Improvements to the Kali Vaitkal an offtake of Vickravanes
river, District. Estimate amounting to Rs 3,100 for

Improving the Kali voikal, an offtake of the Vickramanar.

Report to accompany the estimate for
improving the Kali Voikal an off take of
Vickramanar.

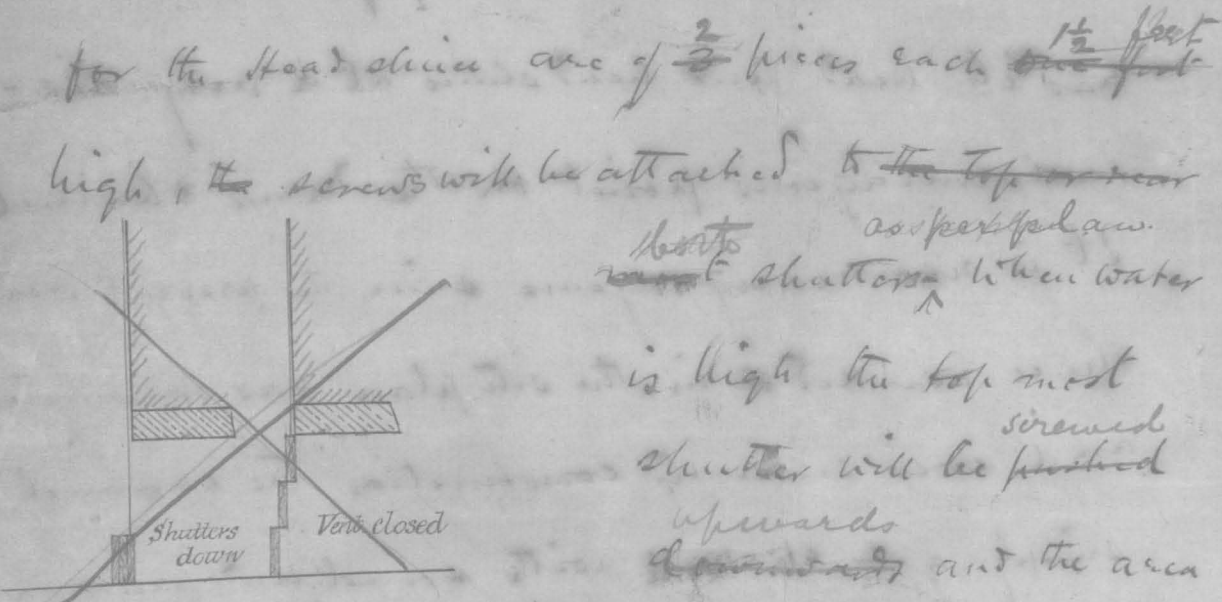
I think that it would be better to make the shutters in two pieces only. I am afraid that it will not do to put in two pieces only.

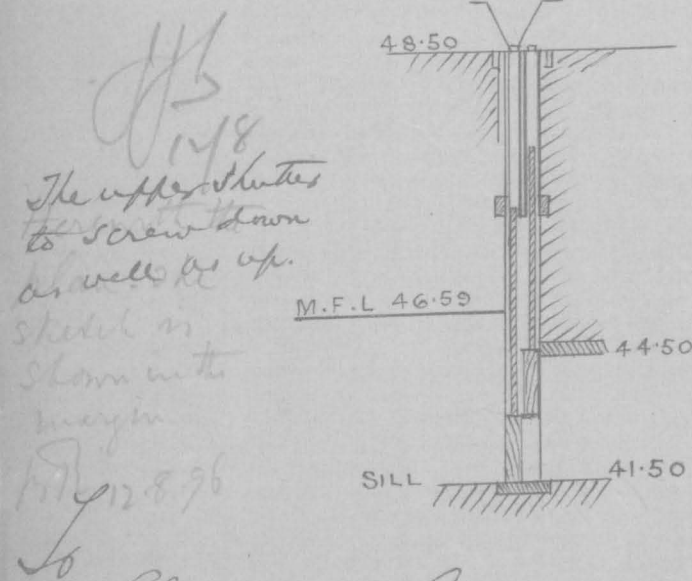
With reference to letter
No. 18282 dated 7th August
1896, from the Superintending
Engineer, Fifth Circle, the
undersigned has the honour
to return herewith the plans
and Estimates amounting
to Rs 2510-0-0 for improv-
ing the Kali Vaitak, an
off take of the Vikramanar,
received with his letter No
14582 dated 18th July 1896.
The shutters may be in
parts as shown in the margin
two, instead of in three
and the Suptg. Engineer
is requested to have the
necessary alterations carried
out in the plans & estimates
before resubmitting them.

Have you got the
plan of the Pulay
Vaitak shown as
attached? E. 1. Without
a sketch S. E. may
not understand the
upper half of shutter
is made to screw down
as well as up.

With reference to your
Memo No. 67 TJ dated 12th August
1896, I have the honour to request
that I may be favoured with
a detailed drawing of the
Screw gearing proposed for the
Kali Vokkal Head Sluice as
I do not understand the sketch
in the margin of the Memo.

The design has been
altered, being simply
two screw sluices,
20^{ft} high each, it
being intended that
water should be taken
off by means of the
upper sluice as long
as possible
